**Florida
Power**
CORPORATION

October 29, 1982
#3F-1082-32
File: 3-F-2

Subject: Crystal River Unit 3
Docket No. 50-302
Operating License No. DPR-72
Generic Letter 81-12 on Fire Protection

FIGURE 4

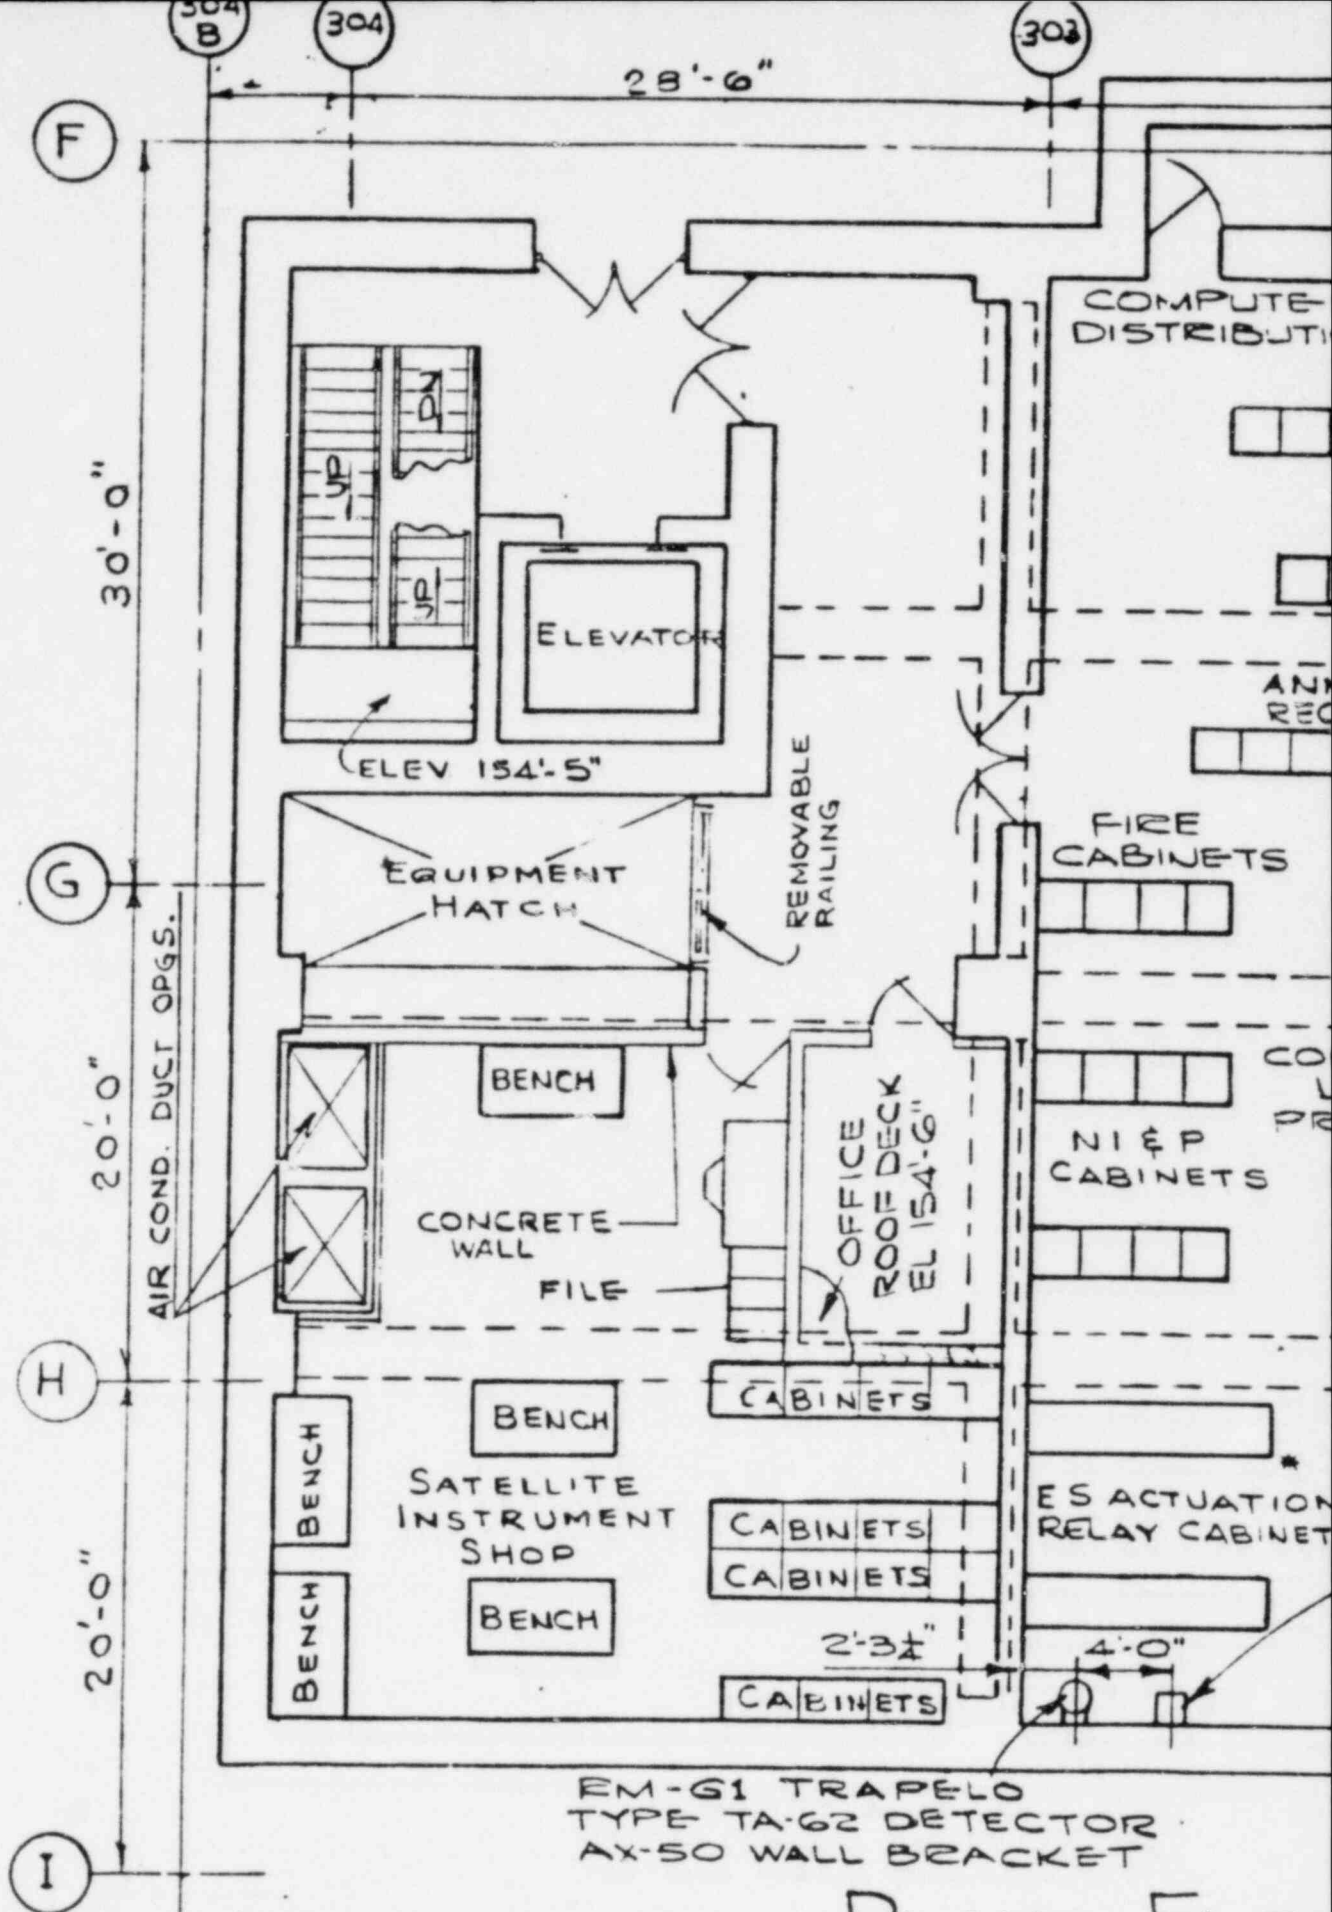
Figures 3 and 6 show the actual location of the dedicated shutdown components and the approximate routing of the circuits. Figures 4 and 5 show the cable spreading room and main control room fire areas. Figures 3, 4, 5, and 6 also verify that no dedicated shutdown components and circuits are located in either the main control room or cable spreading room.
